Issuing Manager/Department: - Tony Stonehewer - Gas Engineering Policy Manager (Transmission)
Approved: - 10/01/2011

Product Alert – BIFFI ELGA & WGR Models of Electric Actuator

Fig.1 – Damaged track on the PCB card

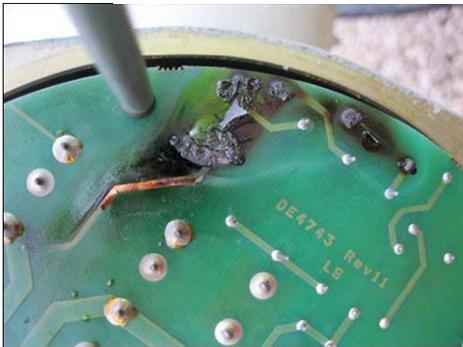
Although the units are still operational, evidence of short circuiting or power surge on the power card has been experienced. The damage has caused the PCB track to come off with severe blackening around the area on the card and inner wall of the control group housing.

BIFFI's engineering department have advised that there have only been a few occurrences of overheating of these three resistors on the power card. The resistors act as suppressors on the high voltage circuit and are there to eliminate interference when the electric motor is running. In extreme circumstance on high voltage units (>500 v) that are subject to repeated use over short periods of time, overheating of the resistors can occur damaging the resistors and connecting track on the PCB card.

It should be noted that the problem ONLY effects units manufactured in 2006, BIFFI identified the potential problem and have revised the resistor values on all units from 2007 onwards.

1. Visually inspect the actuator nameplate to check date of manufacture, its location on the nameplate has been circled in Fig.3.
2. If found to be manufactured during 2006,
 - a. Remove control group housing to inspect for signs of short circuiting or overheating, as shown in Fig.1 & 2. **Note : All electrical supplies must be isolated prior to removal of covers.**
 - b. Contact Steve Johnstone (07867-905922) or Steve Law (07767-382862) for further guidance.
